**TO:** Mayor Vincent Williams, City of Union City  
**ATTN TO:** Anthony Alston, Community Development Director, City of Union City  
**FROM:** Mike Alexander, COO, Atlanta Regional Commission  
**RE:** Development of Regional Impact (DRI) Review

**Name of Proposal:** ATL11 DRI 4235

**Description:** A DRI review of a proposal to construct a data center project with approximately 2,101,500 million SF of space in 3 buildings with associated support facilities on a 62.7-acre mostly wooded site at 4800 Stonewall Tell Road in the City of Union City.

**ATL 11 DRI**  
**City of Union City**  
**Natural Resources Review Comments**  
**October 3, 2024**

DRI SITE PLAN

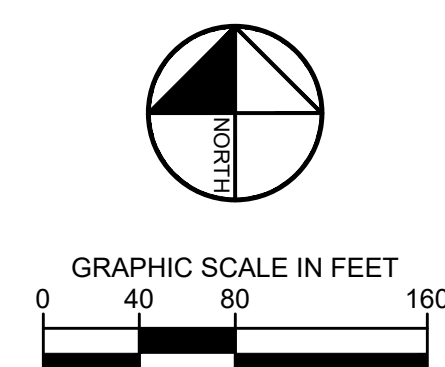
The USGS coverage for the project area and the submitted site plan both show a blue-line tributary of Wolf Creek, which in turn is a tributary of Camp Creek starting at the existing pond on the property and then running north through the property. The submitted site plans also show an intermittent stream entering the perennial stream from the west. The site plans show and identify the 25-foot State Sediment and Erosion Control Buffer as well as the City 50-foot undisturbed buffer and 75-foot impervious setback on both streams. However, the location of the proposed electrical substation is shown over the existing pond and the headwaters of the perennial stream and covering the buffers. These intrusions may require variances and mitigation from the appropriate agencies. No other intrusions are shown on the site plan.

The USGS coverage for the project area and the submitted site plan both show a blue-line tributary of Wolf Creek, which in turn is a tributary of Camp Creek starting at the existing pond on the property and then running north through the property. The submitted site plans also show an intermittent stream entering the perennial stream from the west. The site plans show and identify the 25-foot State Sediment and Erosion Control Buffer as well as the City 50-foot undisturbed buffer and 75-foot impervious setback on both streams. However, the location of the proposed electrical substation is shown over the existing pond and the headwaters of the perennial stream and covering the buffers. These intrusions may require variances and mitigation from the appropriate agencies. No other intrusions are shown on the site plan.

Any unmapped streams on the property may also be subject to the City buffer requirements. Any unmapped State waters identified on the property may also be subject to the State 25-foot Sediment and Erosion Control buffer.
